SUBDIVISION REVIEW SHEET

CASE NO.: C8-2015-0092

SUBDIVISION NAME: The Enclave at Arch Hill

SUBJECT: Variance Request for The Enclave at Archhill
Case Number – C8-2015-0092

1 FLAG LOT CONCEPT VEHICLE & UTILITY ACCESS
SCALE: 1" = 10'

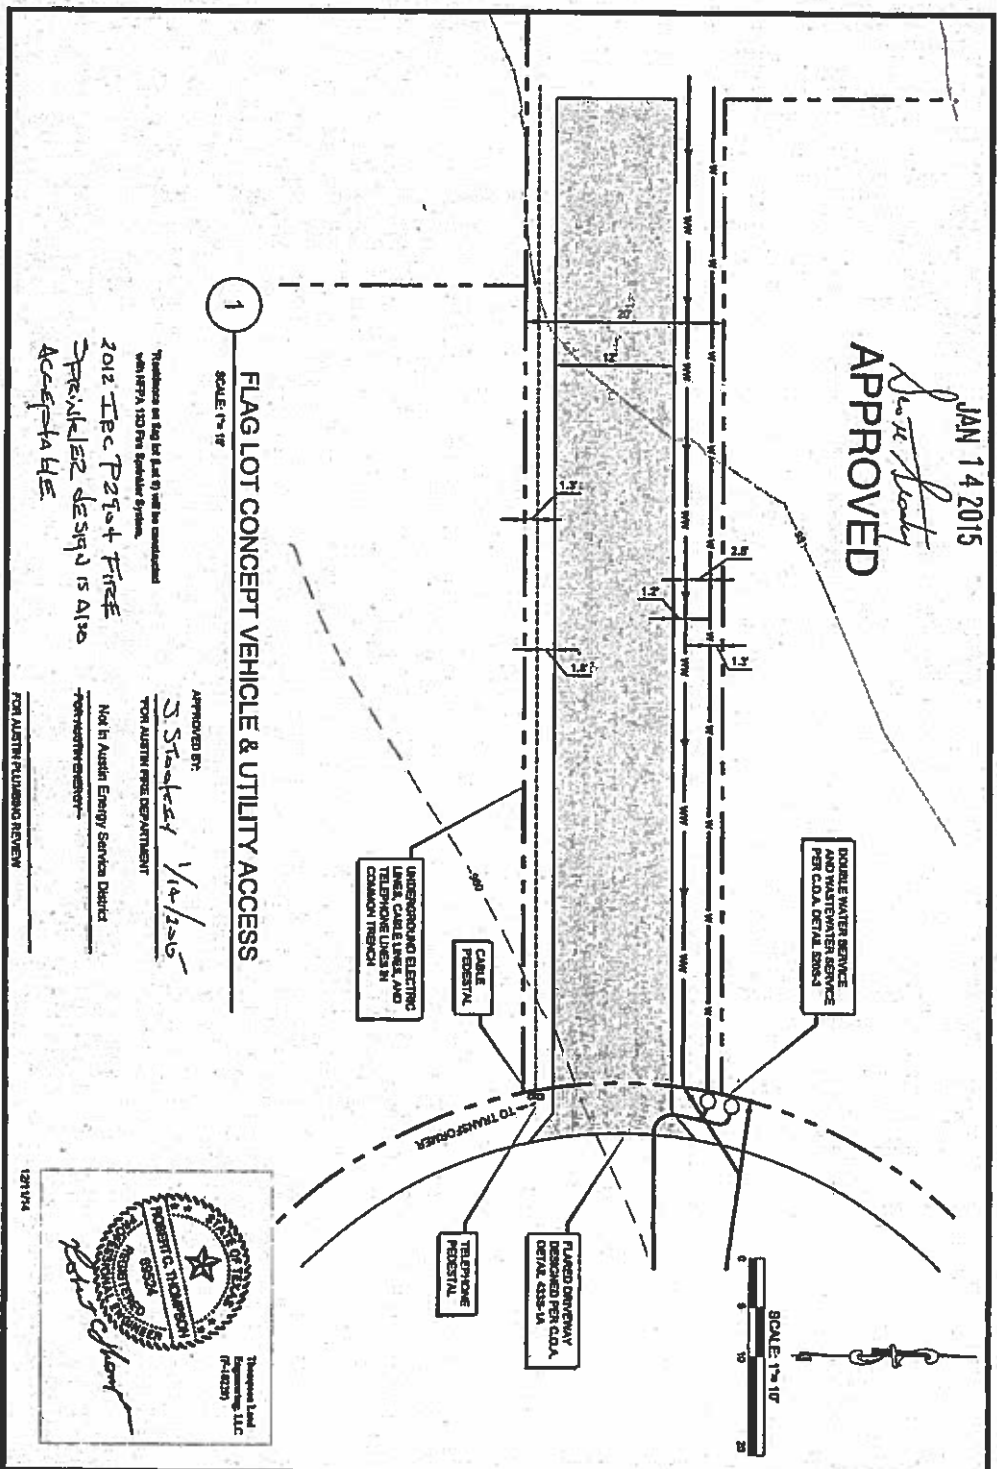
VARIANCE: A variance to L.D.C Section 25-4-175 to allow a residential flag lot has been requested for Lot 9. The applicant has obtained approval from the Fire Department (Ex. # 2) to verify accessibility for emergency responders, approval from the Austin Water Utility (Ex. # 3), and the City Arborist to verify there is adequate room for the required utilities and enhanced tree protection on the site. The flag lot has a 20 foot width and follows requirements listed in Section 25-4-175(B)(2) minimum width of a flag lot.

1
2012 IPC Part Five
Specialized design is also
Acceptable

APPROVED BY:
J. Stokley 1/14/2015
Not in Austin Emergency Service District
FOR AUSTIN FIRE DEPARTMENT REVIEW
